Observation Report 04.02 – 11.02.2021

P123/RF/PS_Rimex – Butyl Rub Silicone/Tape Installed/missing

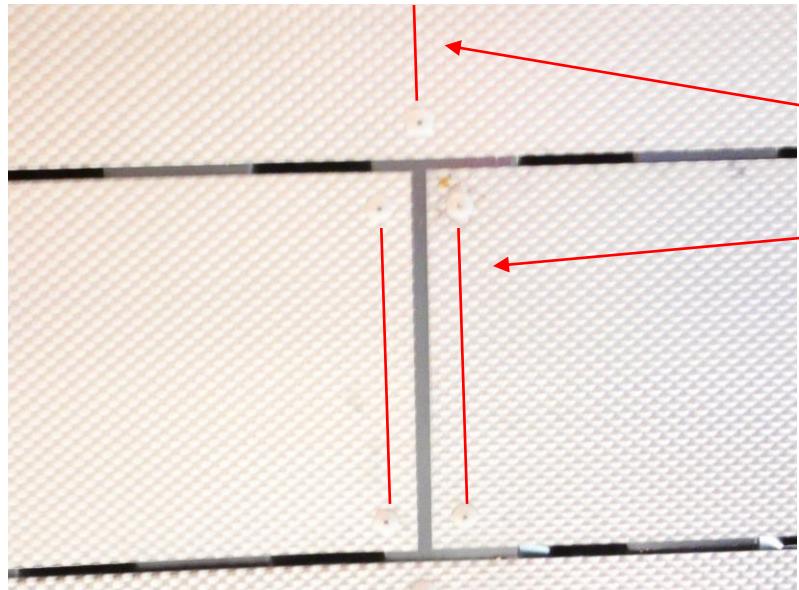
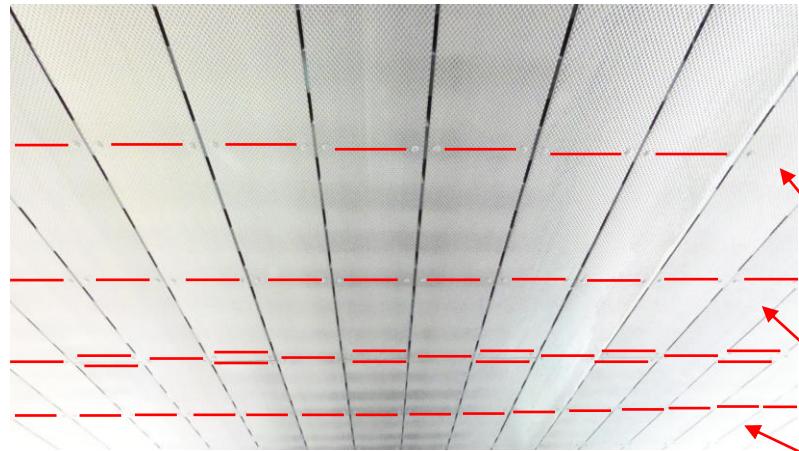
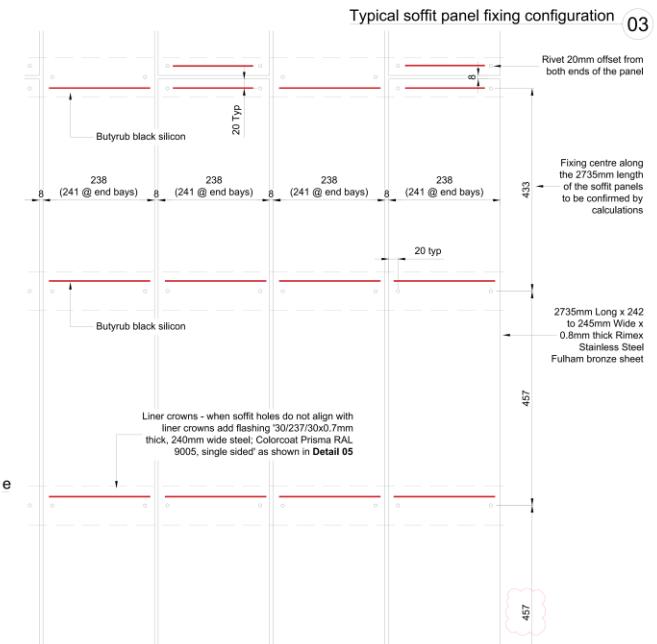
There is possibility that Kaicer not Installed or Poor installed uknow type of product. Rimex panels will be randomly check.

Butyl Rub
Silicone
missing or
poor applied
– Kaicer to
advise what
type of
silicone/tape
it is.
Techndata
to review

P1/RF/RIM_TR1 – Polycarbonate Fixings poor Installed or missing

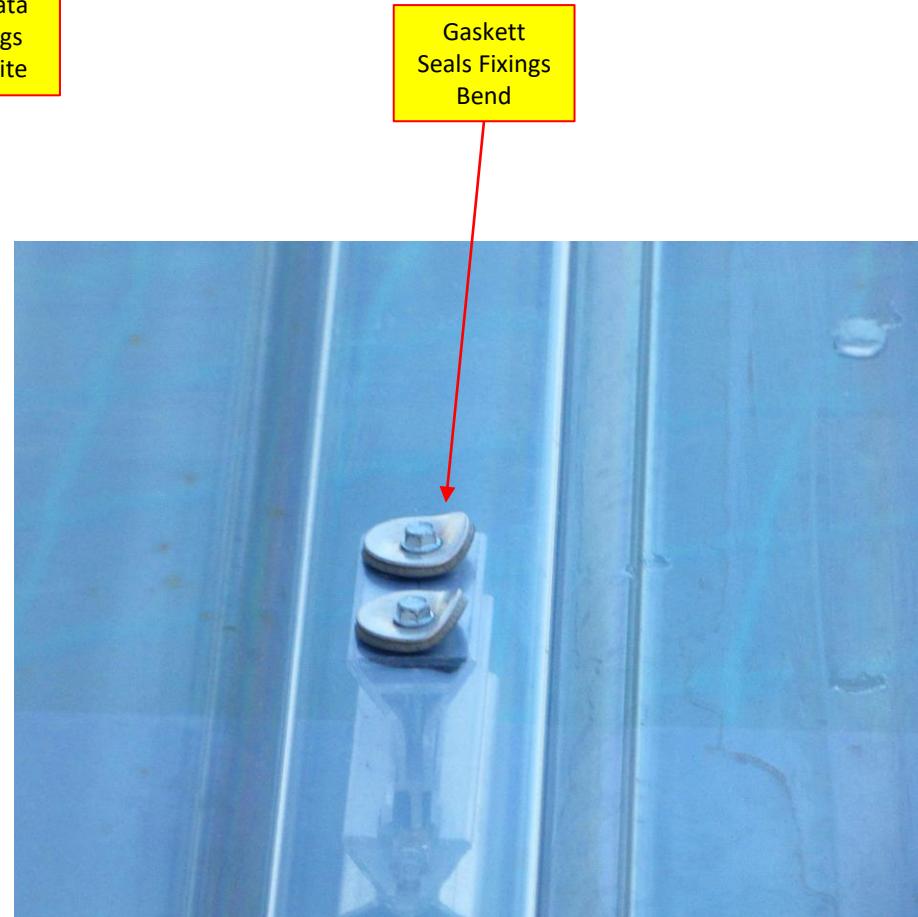
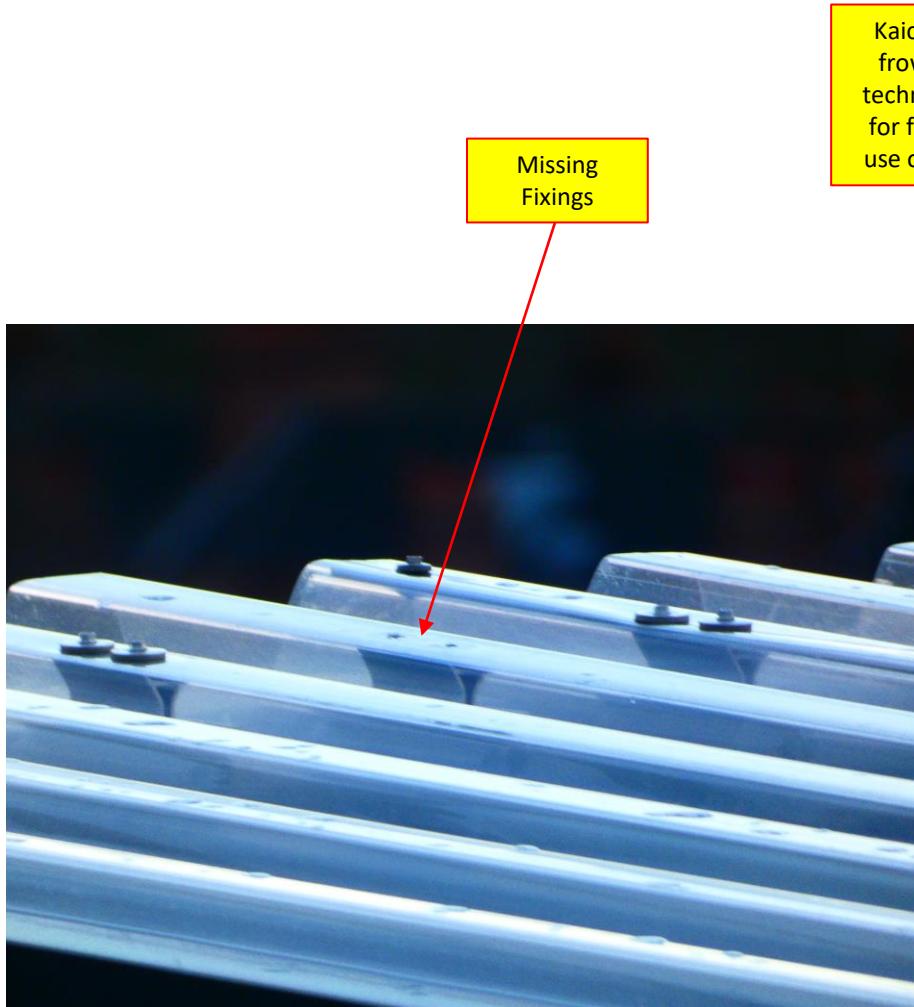
Photo bellow show fixings missing or poorly installed
